**SANTEE COMMUNITY CENTER
CIP 2018-31**

ADDENDUM NO. 4

This Addendum No. 4 (105 pages in total) forms an essential part of the contract documents by revising the following:

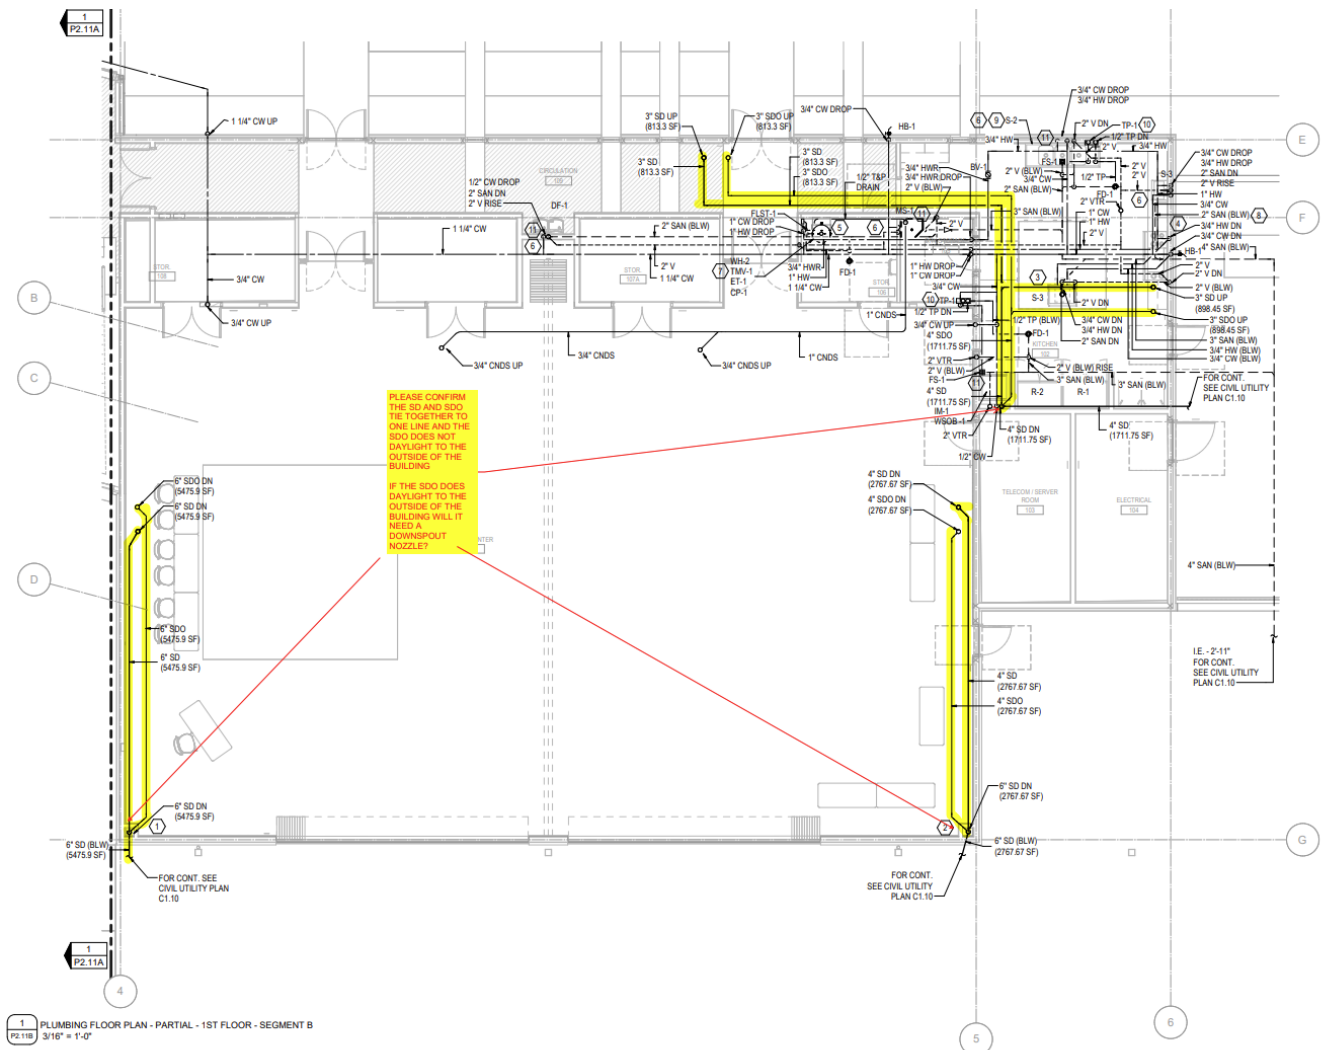
- 4D-4 Question: After review of Sleeves and Sleeve Seals for Plumbing Piping 22 05 17-3.5.A.2.3.41- for the concrete slabs on grade and slabs above grade please confirm all walls will increase in size to accommodate the sleeves called out for in the above specifications i.e.—a 2" riser will require a 4" sleeve (to achieve the 1-inch annular clear space) in turn will need a 6" wall. If this is not required for slabs on grade please advise if the industry standard use of foam wrap will be acceptable to create an annular space between the slab and plumbing risers. For the slabs above grade please advise if a Hilti Fire rated sleeve will be acceptable. For plumbing risers passing from the 1st floor to the 2nd floor

Response: Omit slab on grade specification section as the industry standards use of foam wrap is acceptable. For slabs above grade, the Hilti fire rated sleeve is acceptable.

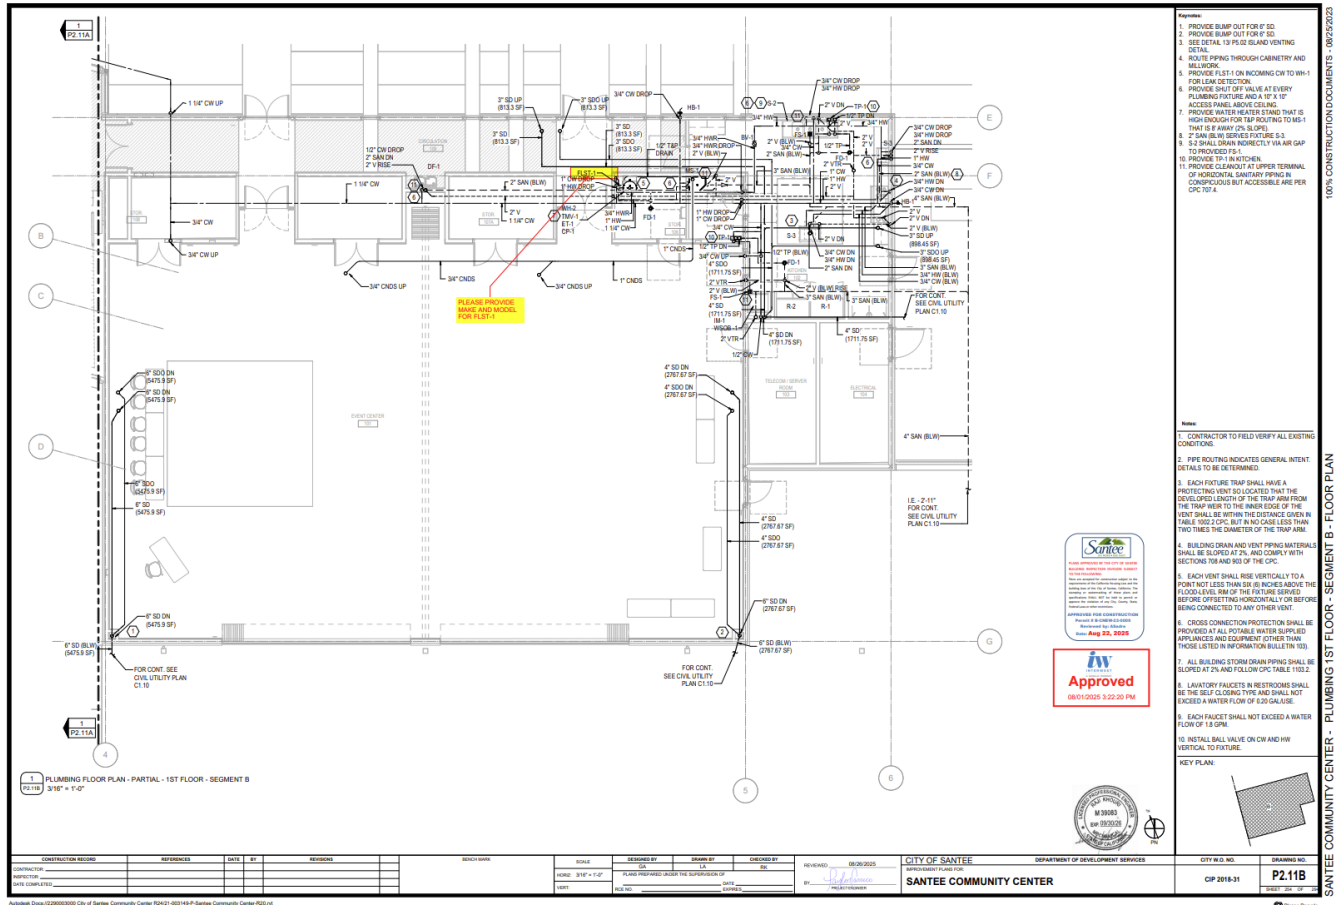
4D-8 Question: The specifications for the Santee Community Center project state that the Fabricator and Installer must be AISC certified. One of our subcontractors is not AISC certified but is a City of Los Angeles Approved Fabricator and has completed similar projects successfully. Please confirm whether a City of Los Angeles Approved Fabricator would be acceptable in lieu of AISC certification.

Response: LA City certified is acceptable.

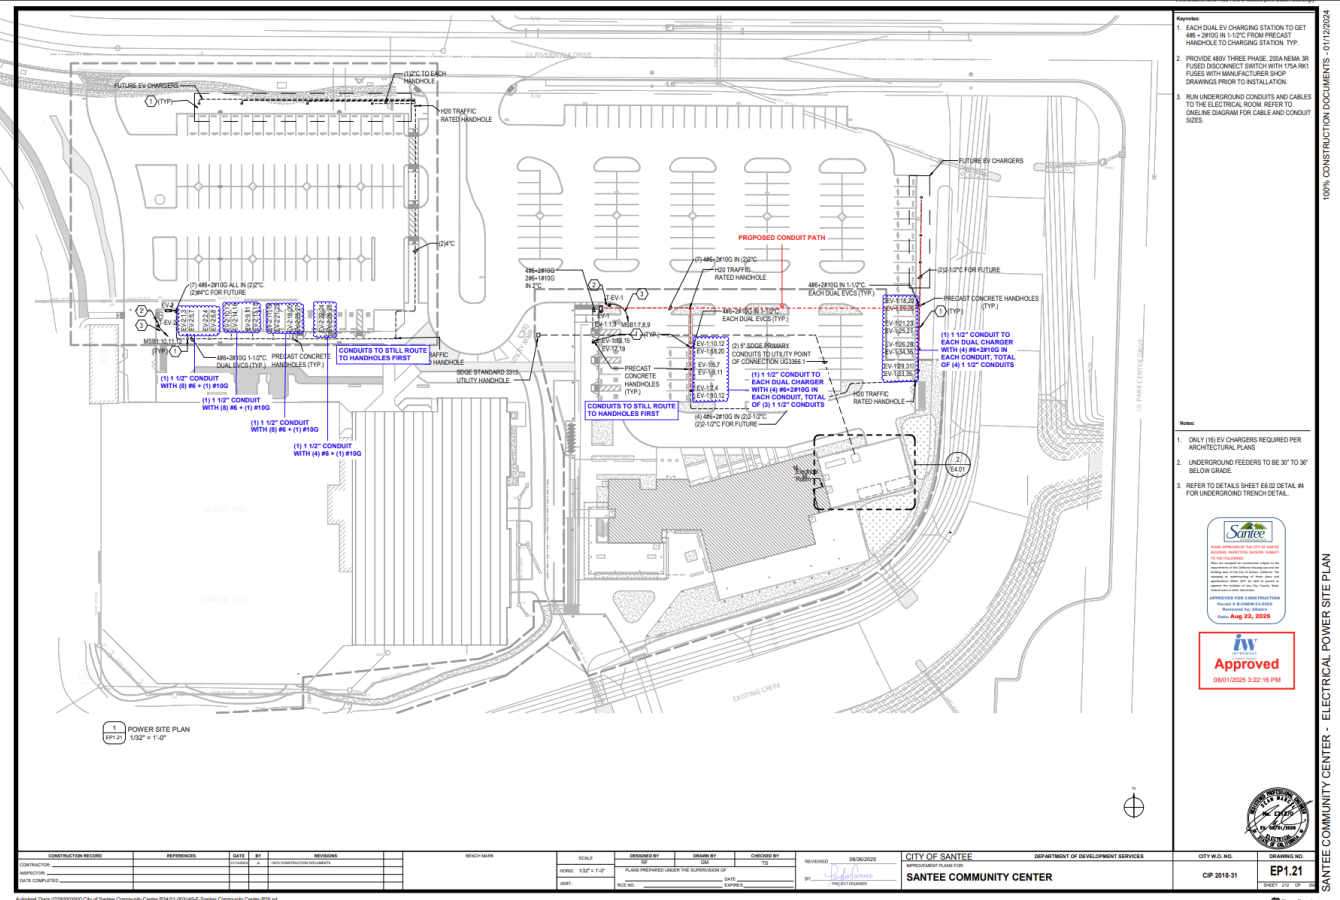
4D-71 Question: Floorplan A2.21, building section 1/A6.11, and wall section 3/A6.23 all call out 7/A10.91 for a detail of the 2nd floor exterior deck railing. This seems to be the only detail on this railing, yet it does not specify what kind of railing this is. Please confirm what kind of railing this is.

Response: The top is to be a flatbar with cable rails below.

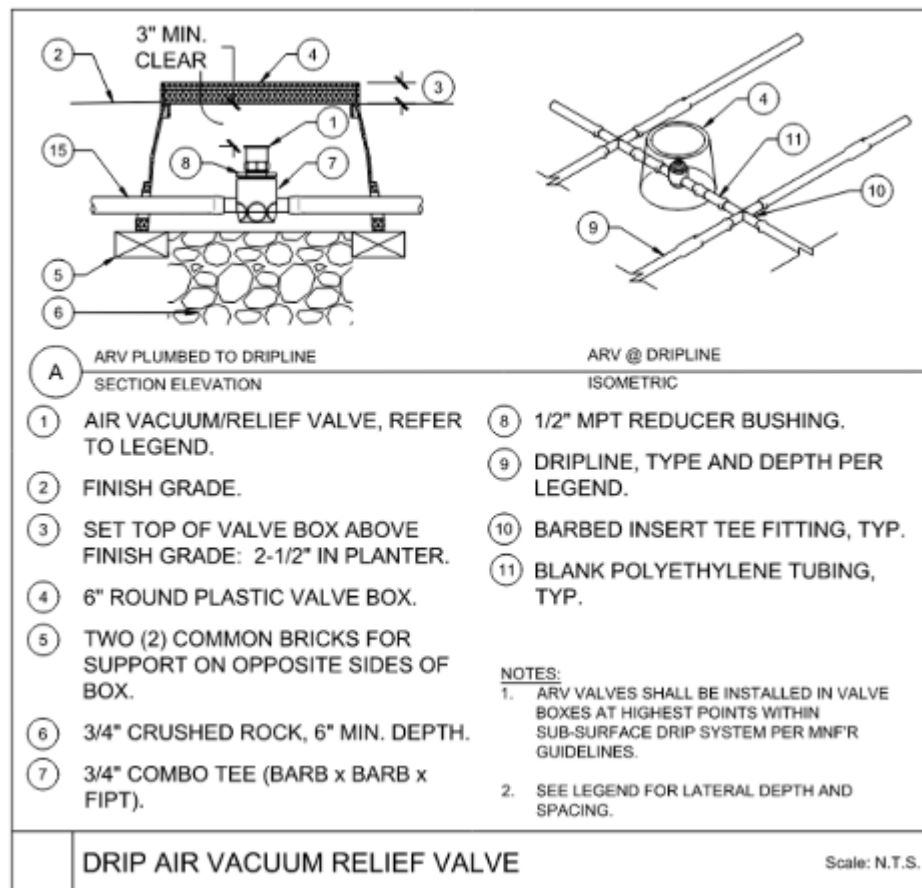
4D-86 Question: Section 329113/3.5 provides different amendment rates for soil receiving imported topsoil and soil not receiving it. Please clarify which planting areas are to receive imported topsoil and which are not.

Response: Will be dependent on soils testing what, if any, of the areas need soil replacement vs soil amendment.

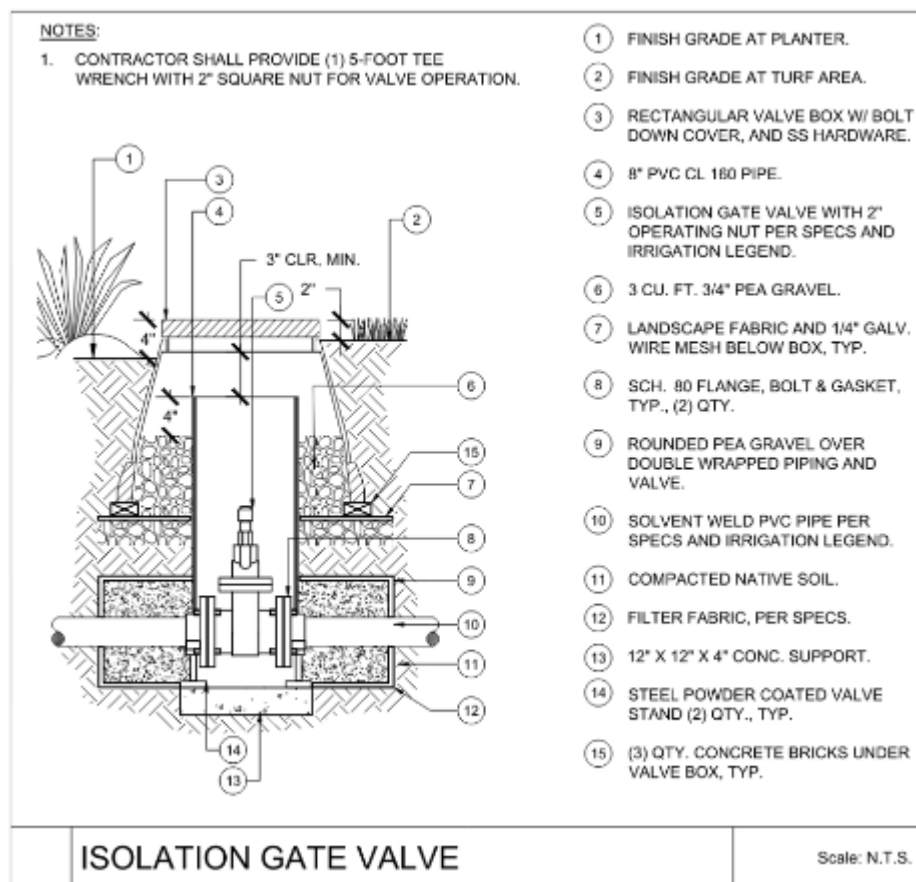
4D-90 Question: Detail 8/L2.52 Note 16 indicates to omit the ball valve when used on a manifold, while Detail 4/L2.51 shows ball valves for each RCV. Please clarify.

Response: Install a manifold ball valve and a ball valve prior to each remote control valve.
Note 16 is incorrect.
